Review of the Byron/Braidwood Units 1 and 2 Auxiliary Feedwater System Reliability Analysis

Brookhaven National Laboratory

Prepared for
U.S. Nuclear Regulatory
Commission

Manuscript Completed: December 1982
Date Published: November 1983

FIGURE 1.1

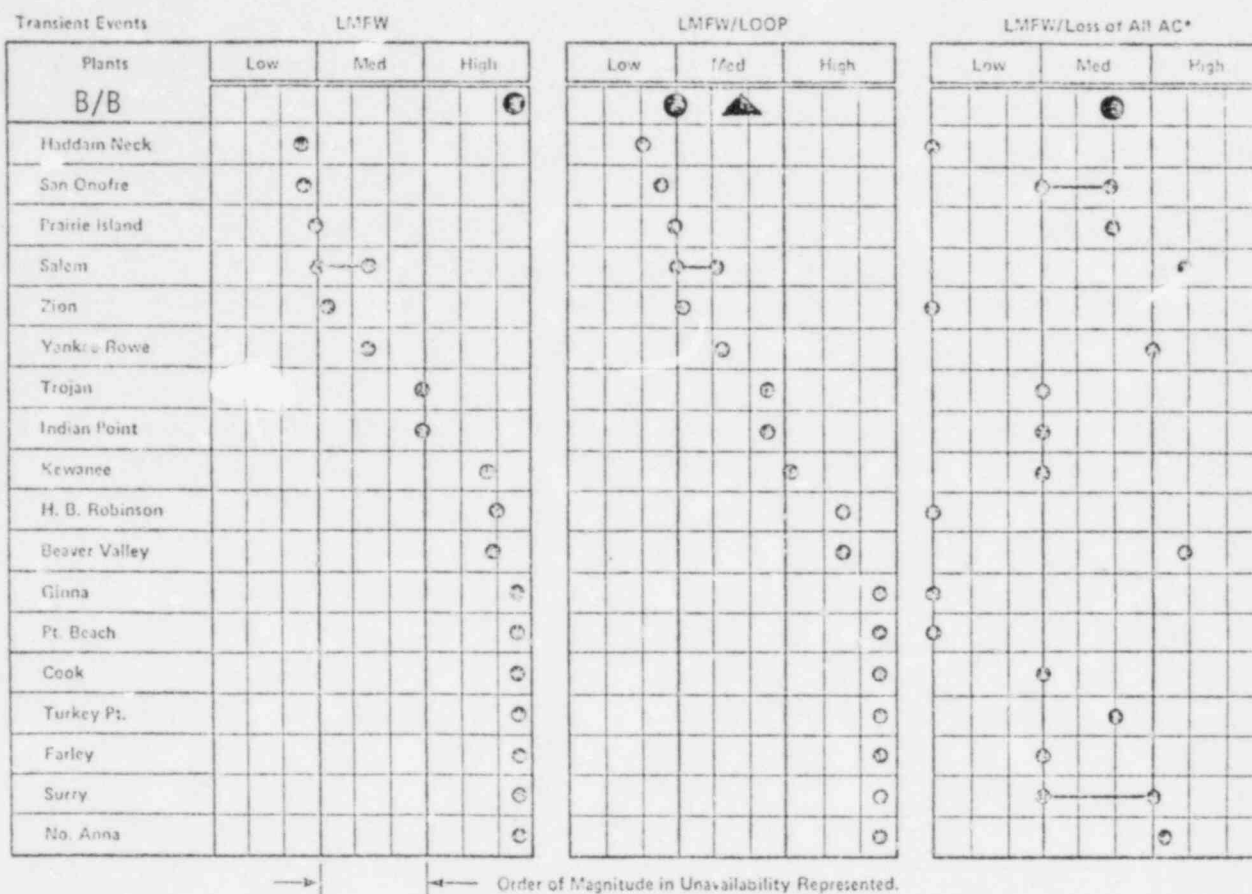
The AFWS unavailabilities are calculated in Table 3.4 and plotted in Figure 1.1.

For LMFV, the unavailability of the AFWS plus startup train is 1.2×10^{-5} /demand, which is "High" reliability. For LOOP, the unavailability of the AFWS is 2.6×10^{-4} /demand, assuming an inter unit crosstie and assuming that LOOP affects only one unit (see Appendix C). For LOOP, the reliability is "Medium". For LOAC, the unavailability is 2.1×10^{-2} /demand, which is "Medium".

Recently, the utility has proposed an inter unit connection (see Appendix C) to improve the availability of AC to the EMD pump. This significantly improves the reliability, placing the system at the high end of the "medium" range.

Figure 2.1 Simplified Diagram of AFUS for Byron/Braidwood Units

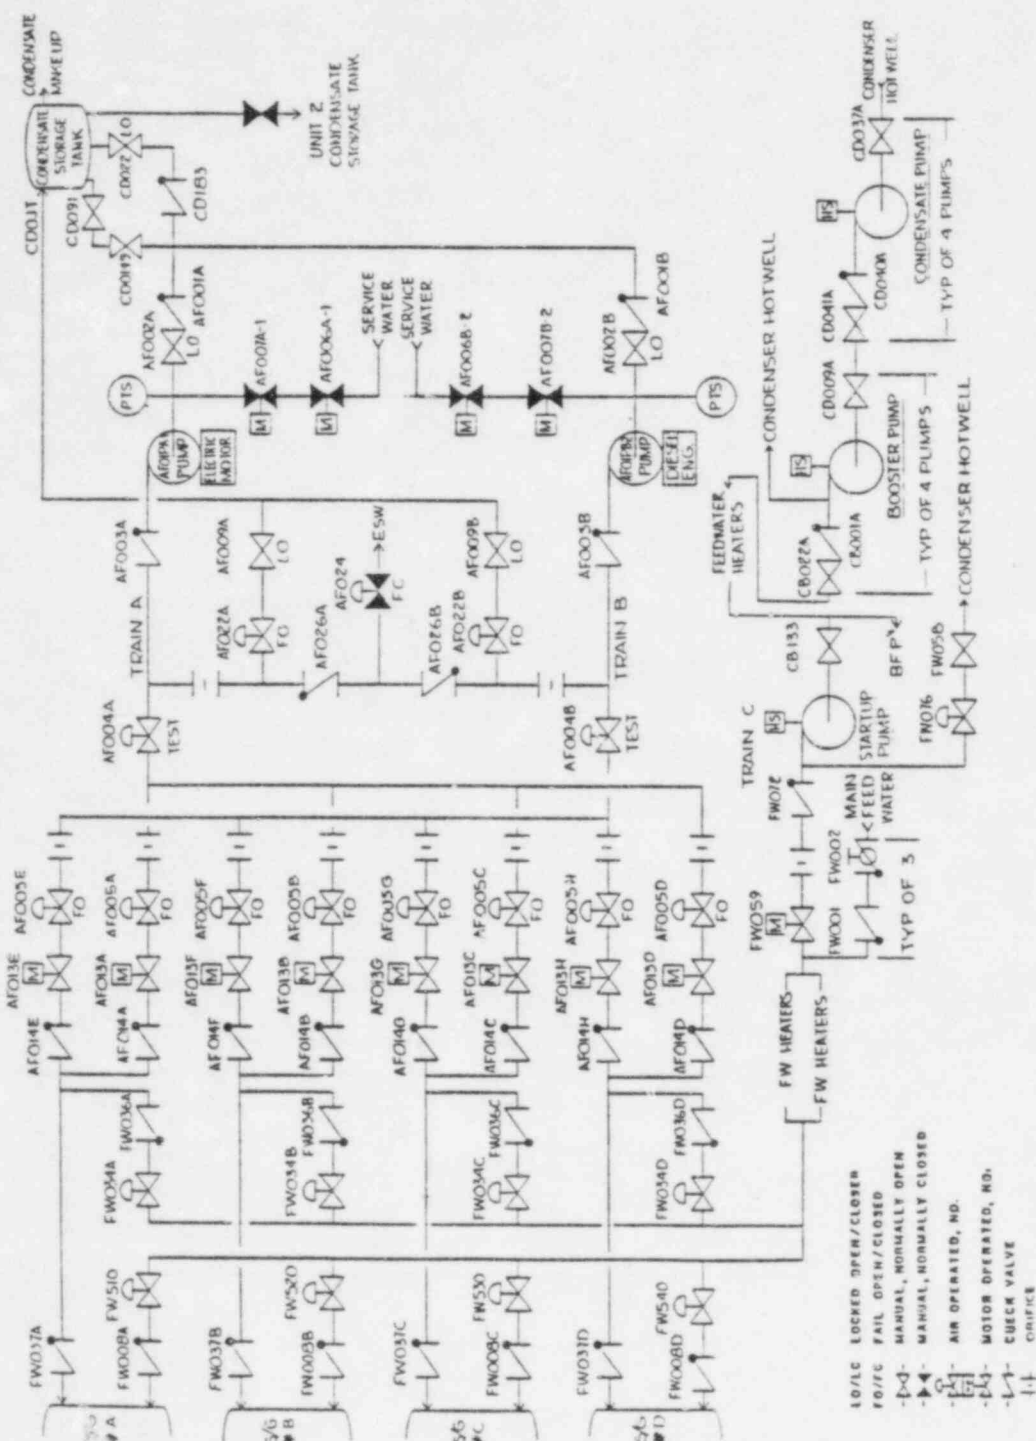
The primary suction source is the condensate storage tank. Redundant flow paths begin at the CST and meet at a header which supplies both pumps (see

Figure 2.1). No single valve can block the flow. In the event of low suction pressure, there is automatic switchover to service water. There are startup suction filters which are further discussed in Section 3.8, on common cause failures.

Flow from each pump goes to all four steam generators through independent paths (refer to Figure 2.1). Flow is controlled by manually controlled air operated normally open control valves which fail open on loss of air. Upstream of the header from which the four discharge paths emerge, there is a valve which is temporarily closed during testing. In the event of a system demand, this valve opens automatically. During the first phase of a pump test, closure of this valve directs flow to recirculation; at the conclusion of a test, the test valve opens, and flow is tested all the way into the steam generators. Thus, no portion of this system stays untested between challenges or shutdowns. There are flow restricting orifices in each path, so that depressurization of a steam generator does not result in excessive diversion of AFW to the faulted steam generator.

Monthly, or after any maintenance act, a full flow test is conducted. During a test, a discharge valve is first closed to direct flow to recirculation (see Figure 2.1). An actual system demand during this period causes this valve to open to permit flow to the steam generators. At the conclusion of the first phase of the test, this valve is opened to permit testing of full flow to the steam generators. If this test is carried out, a significant class of failures is substantially reduced in probability. For example, the analog of leaving a discharge valve closed in another plant corresponds here to leaving a discharge valve closed and disabled and failing to carry out plant policy re testing. This testing policy significantly improves the reliability of the system.

(Refer to Figure 2.1). Then the event "failure to provide flow from one AFWS pump to at least two steam generators" may be written

Barring substantial common cause failures involving multiple-V events, it is easily seen that the dominant contributors are contained in $P_A P_B$.

Figure 3.1 Simplified Fault Tree: Loss of Main Feedwater

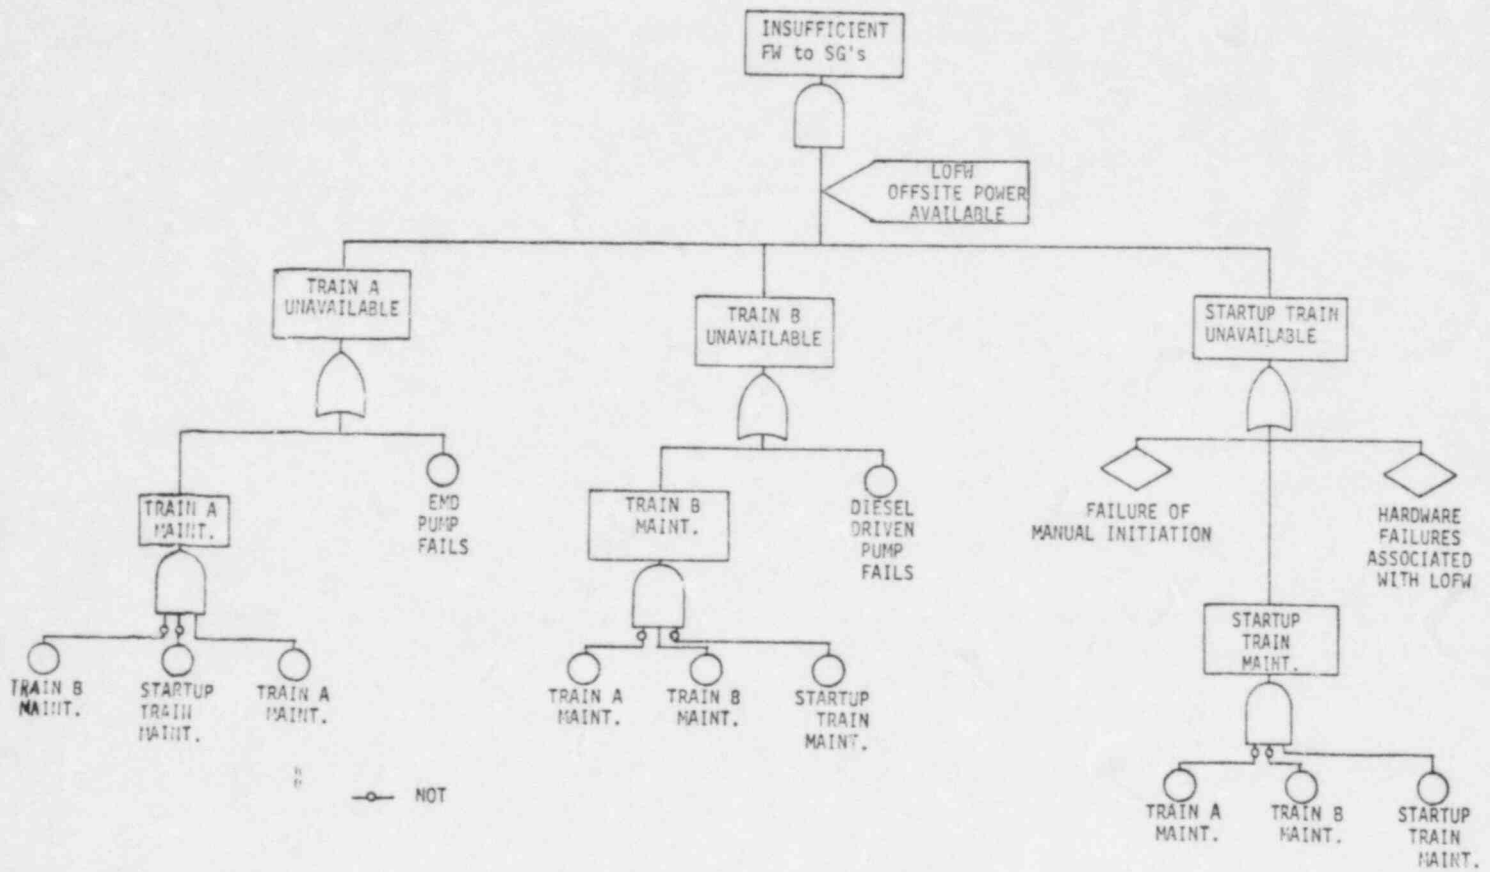
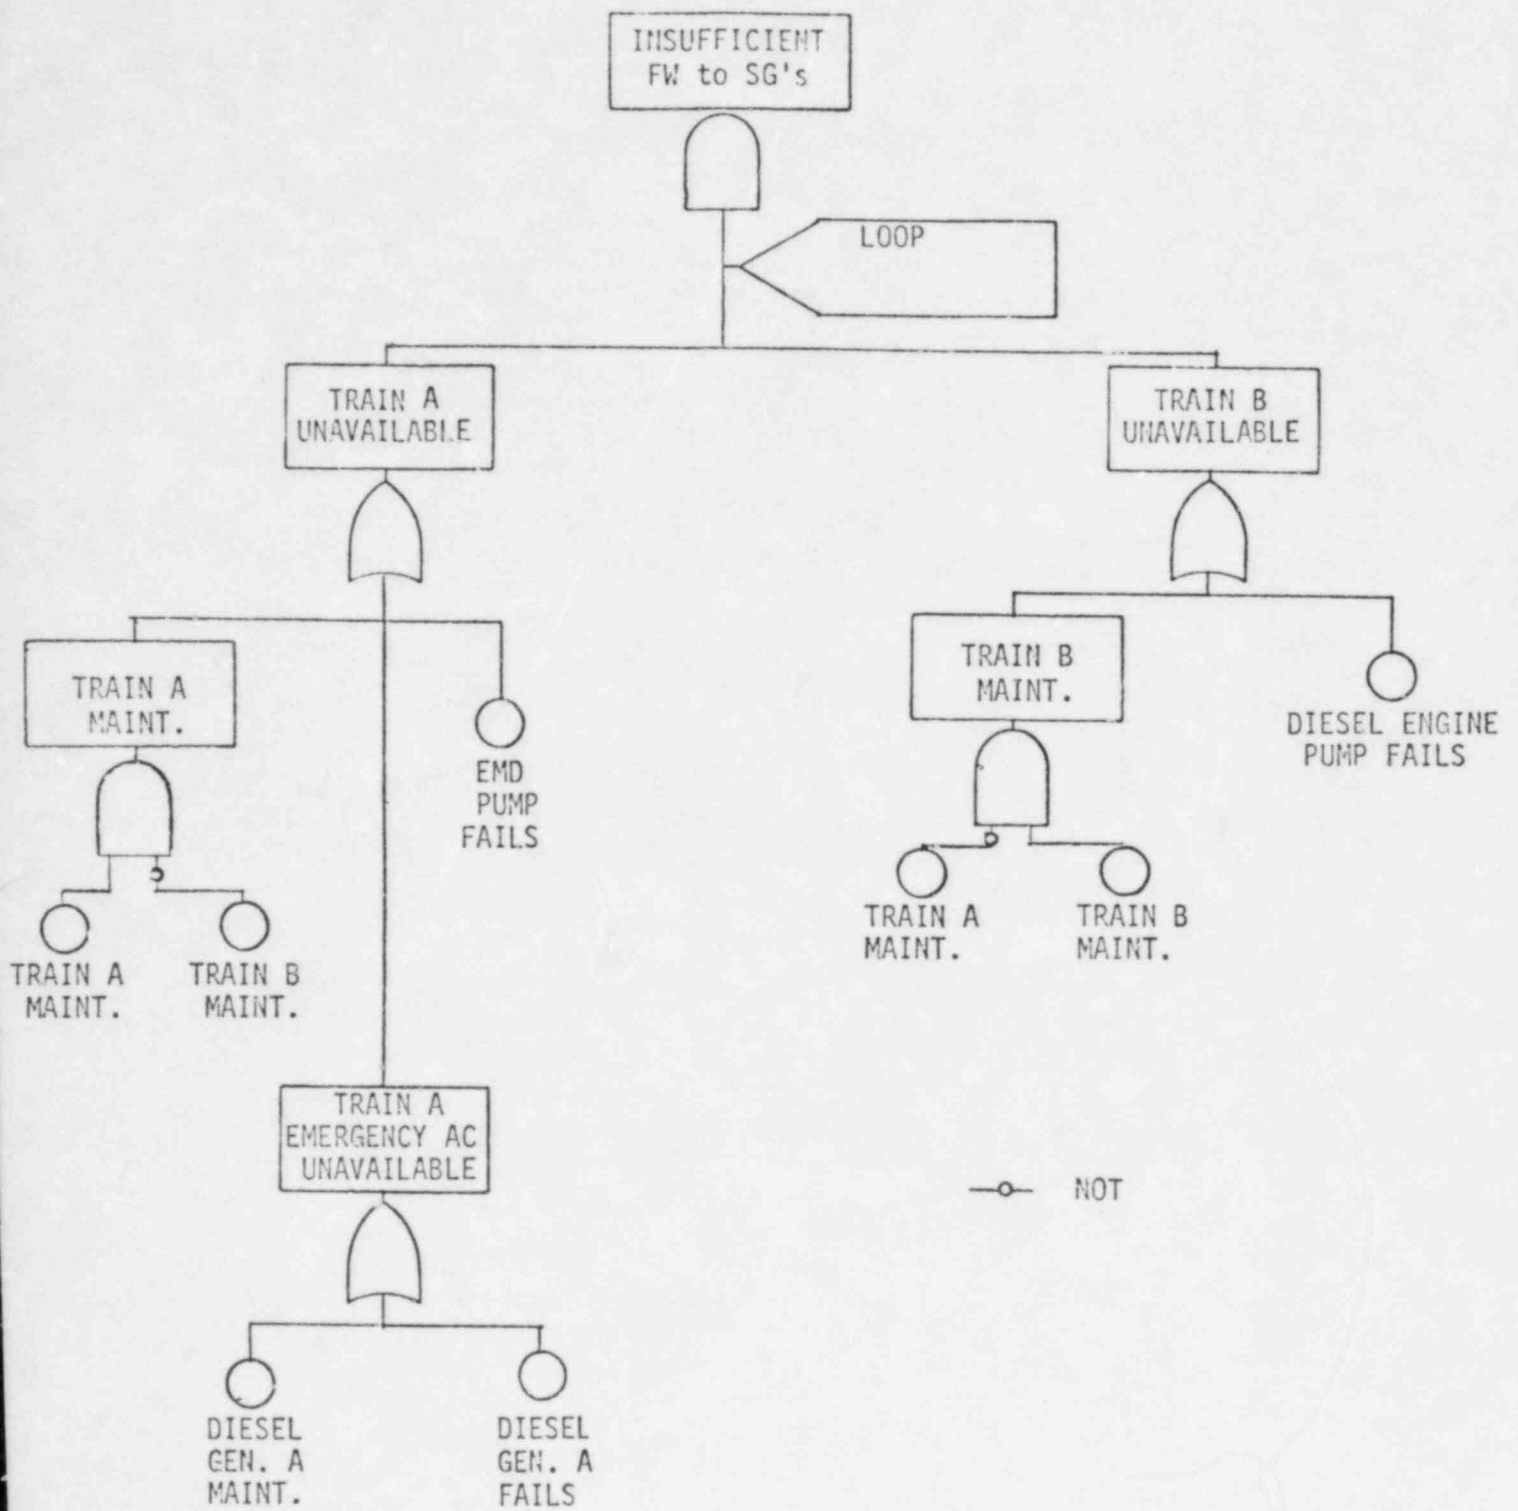
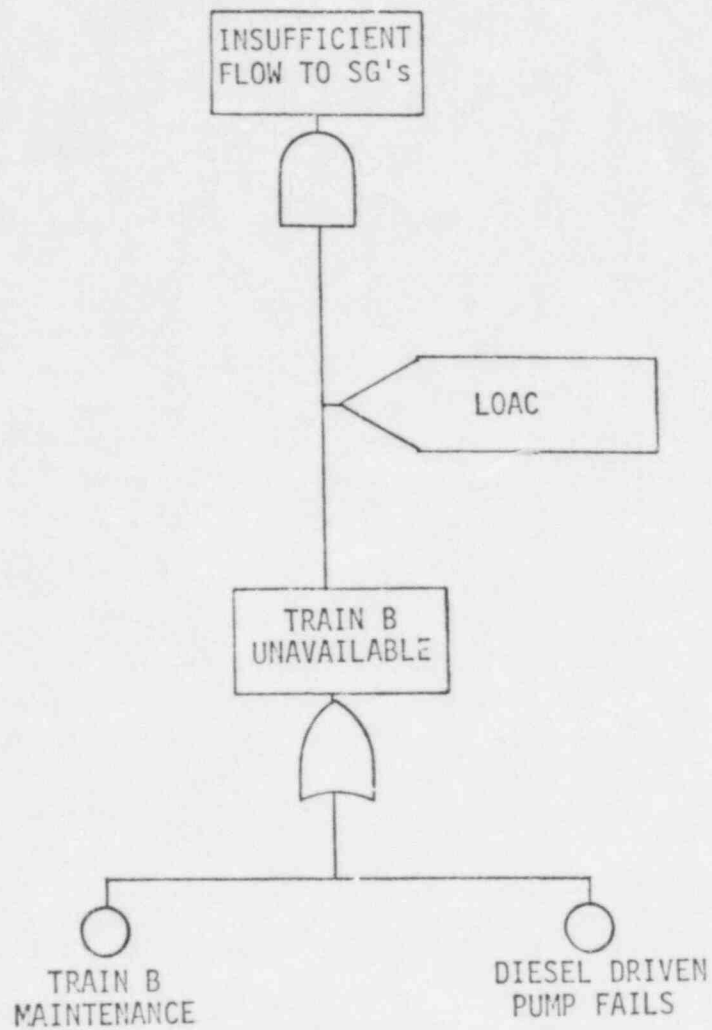
Figures 3.1-3.3 show simplified fault trees for each of the three initiators considered. These reflect the considerations leading up to the above formula.

Figure b-1a: Simplified Fault Tree Core Damage Following Extended Loss of Offsite Power

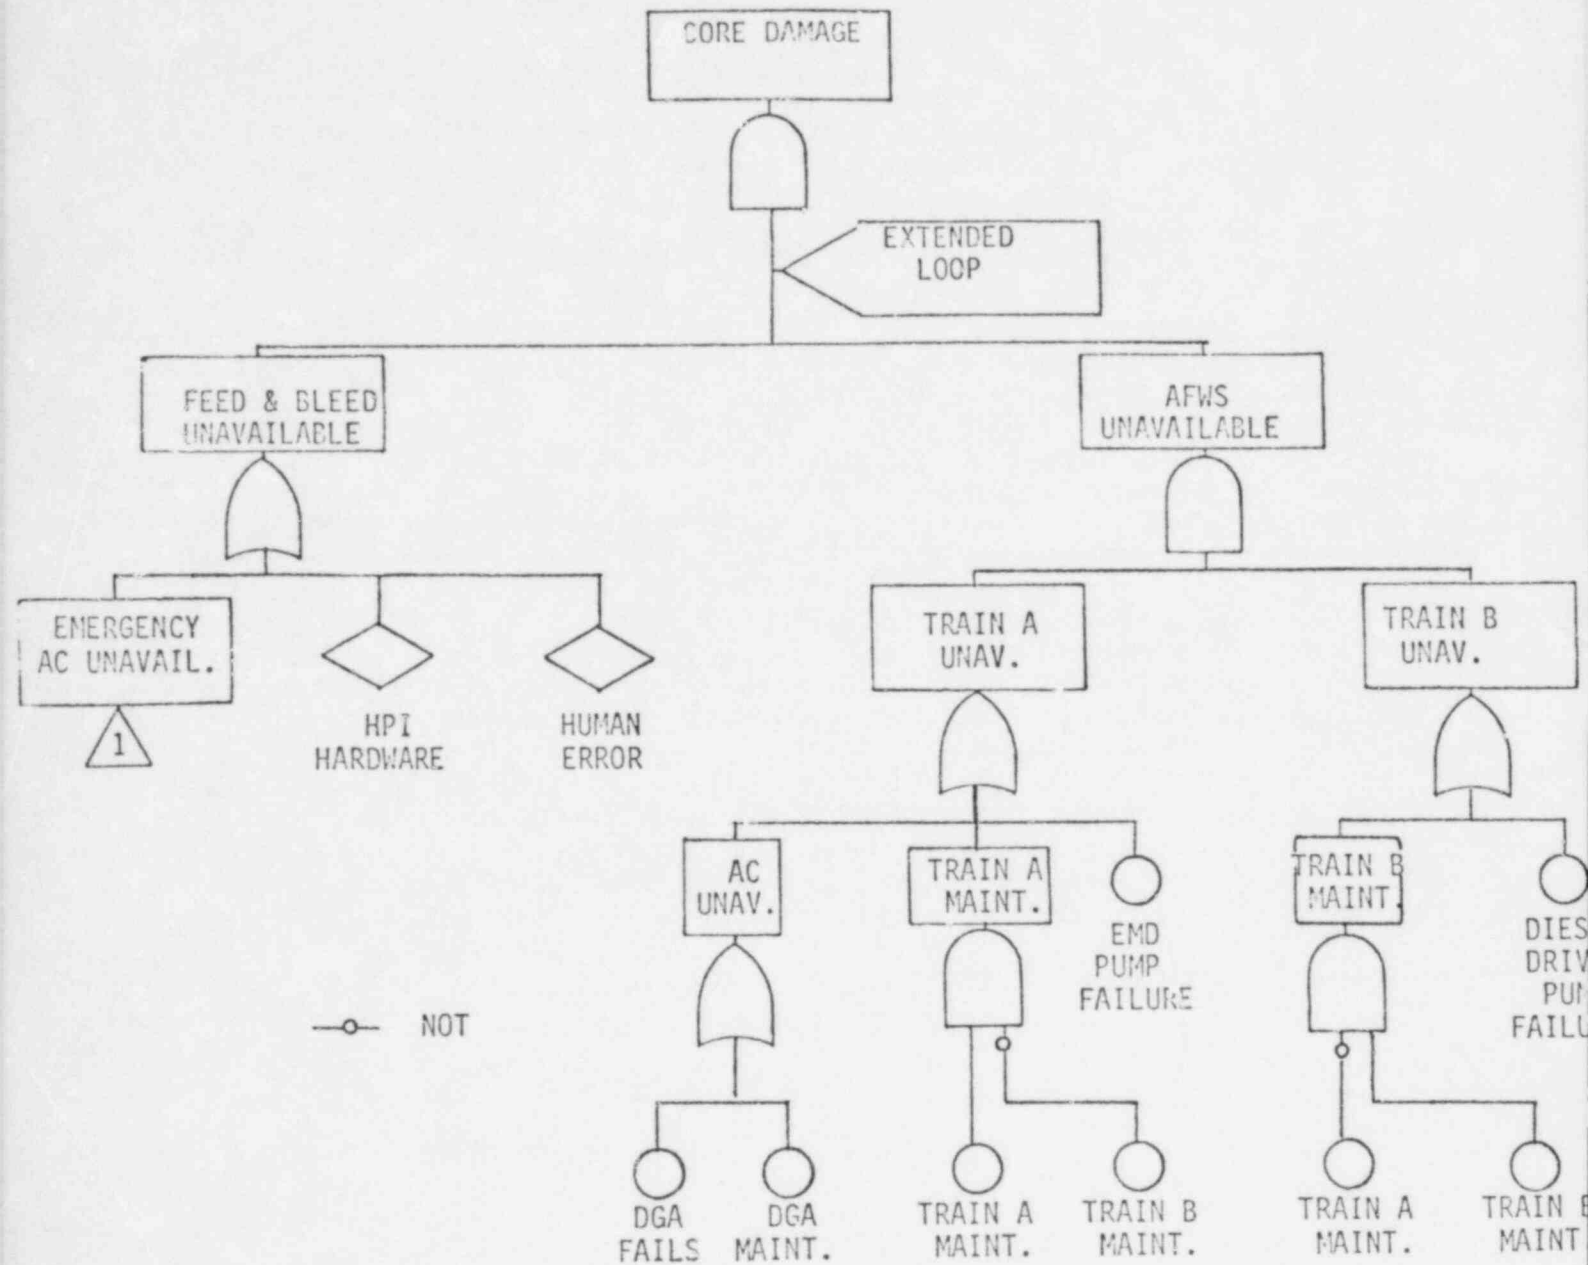
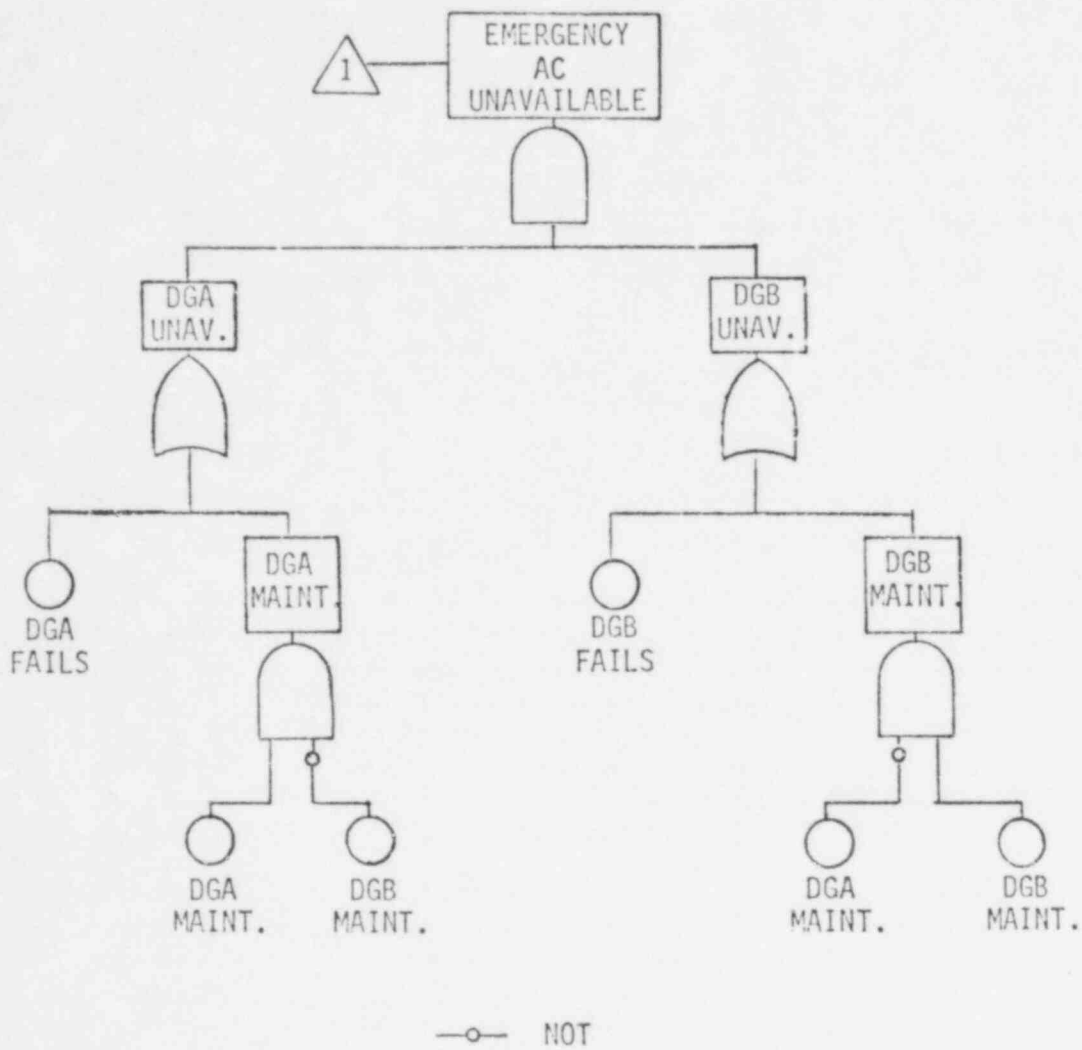
According to the SRP, the AFWS unavailability is to be considered in light of the possibility of other methods of core cooling. One such possibility is "feed-and-bleed," in which primary coolant is permitted to escape through a pressurizer relief valve ("bleed"), and is replenished by the high pressure injection system ("feed"). The present discussion is intended to show how credit for feed-and-bleed can qualitatively alter the conclusion that would be drawn from a survey of the AFWS unavailability alone. It is not intended as a comment on the feasibility of feed-and-bleed in general.

Thus, by using DGB for feed-and-bleed, B/B could argue that their dominant cut sets for core damage given LOOP are the same as those at plants having three-train AFWS's. Such a conclusion is, of course, based on the assumption that failure of emergency AC is the dominant failure mode of feed-and-bleed. Scrutiny of this assumption is beyond the scope of this review.
